Access Compliance Report

Public Rights-of-Way

Intersection ID: 46736	Main Street: ROBINSON_MEADOW_CT	Cross Street: BEAVER_BROOK_WY	Location: NE
ADA ID: 0BC1C3F3839B	Ramp Type: PerpDiag	Initial Pass/Fail: Fail	Overall Compliance: No
Severity Score: 10			
Codes/Mitigation Info/Possible Solution		Field Measurements/Component Compliance

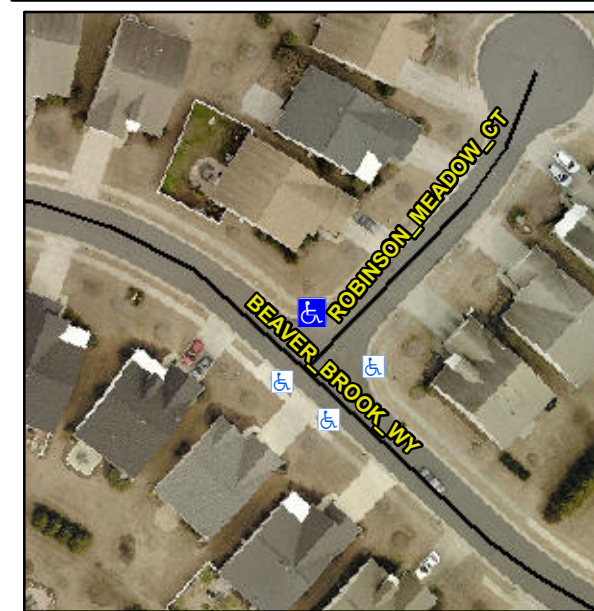
Not Found, R304.5.1, R304.5.3

Compliance	Description	Data	Compliance	Description	Data
N/A	Ramp Length (in)	46.0	Yes	Ramp Slope (%)	6.2
No	Ramp Width (in)	38.0	No	Ramp XSlope (%)	2.8
N/A	Flare Type LT	N/A	N/A	Flare Type RT	N/A
N/A	Flare Slope LT (%)	N/A	N/A	Flare Slope RT (%)	N/A
N/A	Flare Traversable LT?	N/A	N/A	Flare Traversable RT?	N/A
N/A	Landing Length (in)	N/A	N/A	DWS Provided?	N/A
N/A	Landing Width (in)	N/A	N/A	DWS Contrast?	N/A
N/A	Landing Slope (%)	N/A	N/A	DWS Length (in)	N/A
N/A	Landing X Slope (%)	N/A	N/A	DWS Full Width?	N/A
N/A	Landing Curb? (Y/N)	N/A	N/A	DWS Offset (in)	N/A
N/A	Shared Landing?	N/A			
N/A	Gutter Ponding?	Yes	N/A	Gutter Slope (%)	N/A
N/A	Gutter Lip Ht (in)	N/A	N/A	Gutter X Slope (%)	N/A
N/A	Painted X Walk1?	No	N/A	Painted X Walk2?	No
	X Walk 1 Direction	To SW		X Walk 2 Direction	To SE
N/A	X Walk 1 Width (in)	N/A	N/A	X Walk 2 Width (in)	N/A
	X Walk 1 Slope (%)	3.1		X Walk 2 Slope (%)	0.1
	X Walk 1 X Slope (%)	1.0		X Walk 2 X Slope (%)	0.2

Remove & Replace Curb Ramp With Two New Directional Ramps or Equivalent.
